Joint Report on GE Hitachi's Containment Evaluation Method

*A Collaborative Review by the U.S. Nuclear Regulatory Commission
and the Canadian Nuclear Safety Commission*

April 2022

Figure 3: Demonstration Cases

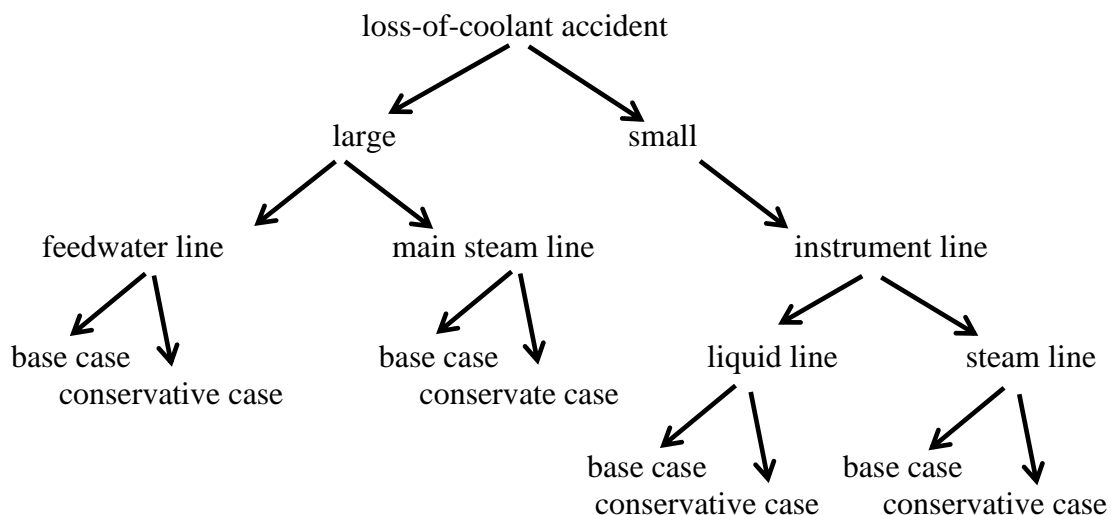
NRC and CNSC staff determined that the modeling of the initial RPV conditions is acceptable. The NRC and CNSC staff reviewed the initial conditions for the base and conservative cases and determined they were correctly selected and biased, as necessary, to produce appropriately conservative results. Additionally, the NRC staff performed independent sensitivity studies using TRACE that supports this.

Given that event classification of design basis accidents in Canada extends to 10^{-5} per year, CNSC staff will check in future licensing engagements if this criterion has implications in the selection of a bounding accident.
